Concept design peer review

Googong Township water cycle project

Subject: Technical Review of Googong Integrated Water  
Cycle Management Strategy: Water & Wastewater  
Concept Design

# TECHNICAL REVIEW OF THE GOOGONG INTEGRATED WATER CYCLE MANAGEMENT STRATEGY: WATER & WASTEWATER CONCEPT DESIGN

## **Process selection and chemical P removal**

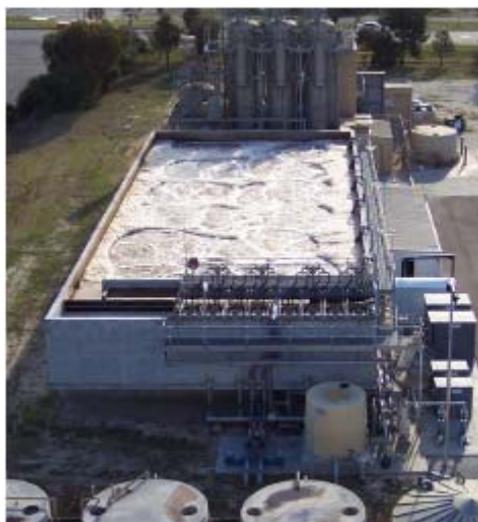
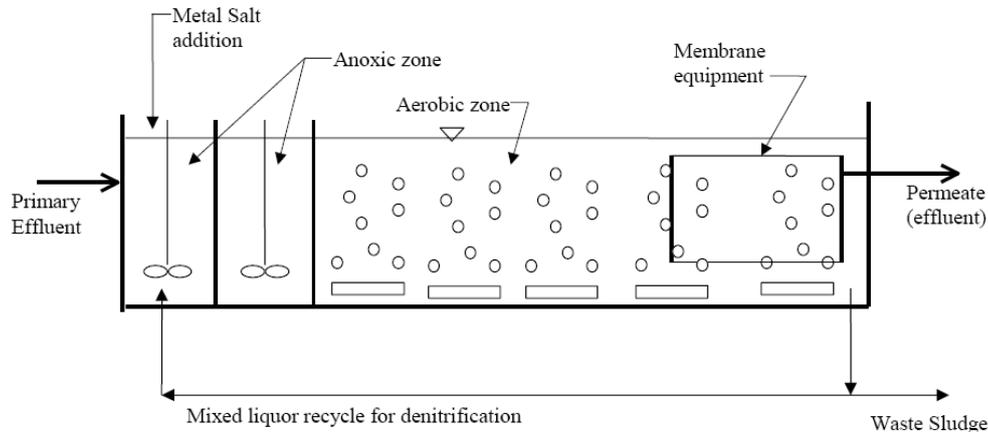
8. A MLE process has in the past been selected when chemical P removal is proposed with an MBR. There are several examples around the world and Australia currently in operation. Victor Harbour MBR WWTP is one example that comes to mind put in by Tenix. This MBR is shown below and was designed for a 3.6 MLD ADWF with an ultimate peak wet weather flow of 11.2 MLD. Effluent in this case is reused for local irrigation and to provide environmental flows.

Often the submerged membranes are included at the end of the tank (as shown above and below), rather than a separate membrane tank, which lowers both capital and operating costs (no extra pumps). In other cases pressure membranes are external to the bioreactor.

What is the rationale for:

MWH Response: Refer to the Options report. Membranes have been put outside the tank as no decision has been made on the type of membranes and to decrease the opportunity for ammonia breakthrough (conservative approach on the basis that no membranes have been selected but we know some units require a separate tank. This will be re-examined by detailed designers.

BV Response: The Options Report was not given as part of the original review material. A copy was later forwarded to the reviewer.

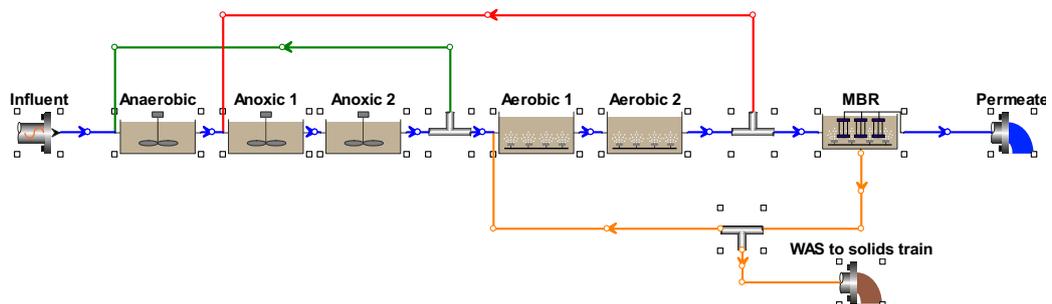
The COD/P = 48 with the report numbers; a value > 35 is normally considered well on the way to an effluent total phosphorus concentration of ca 1 mg/L or less (Randall et al. 1992).

Add an upfront anaerobic tank to the preferred process (with proper recycle streams) and process reconfiguration, you could have a Johannesburg Configuration (for instance).

Biowin 3.1 now has the MBR for BNR selection as an option (this would require some “twigging” of course). I was able to reduce phosphorus to well below 1 mg/L (without iron) using the numbers from the Concept Design report by adding some methanol ahead of the aerobic systems. This also helped with the nitrate and the pH was about 6.9. This process would require more “twigging” but it does seem possible.
